Addendum Number 1

HVAC Upgrades 2nd. Floor (Temperature Controls)
Southern University and A&M College
Southern University Law Center
Baton Rouge, Louisiana 70813

Southern University Law School HVAC Upgrades (Temperature Controls)

ADDENDUM No. 1

1. <u>M100 PARTIAL 2nd FLOOR MECHANICAL PLAN</u>

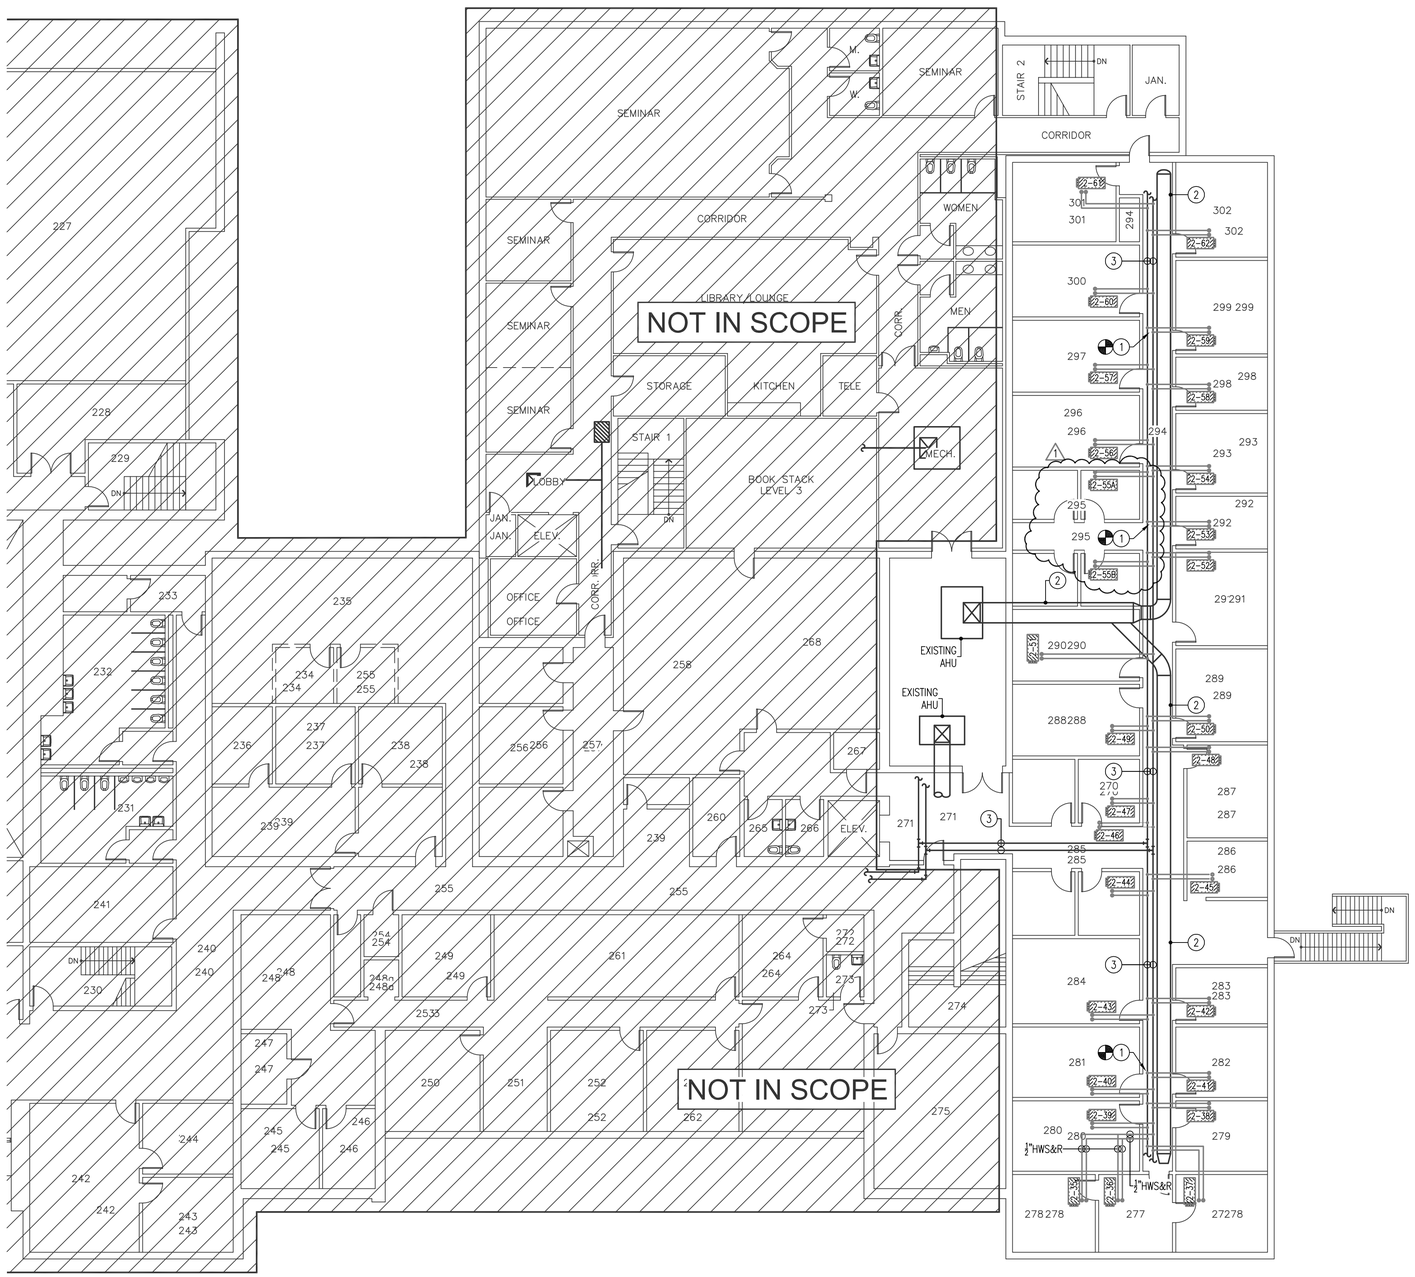
a. Refer to attached revised sheet for additional VAV box 55B and associated ductwork.
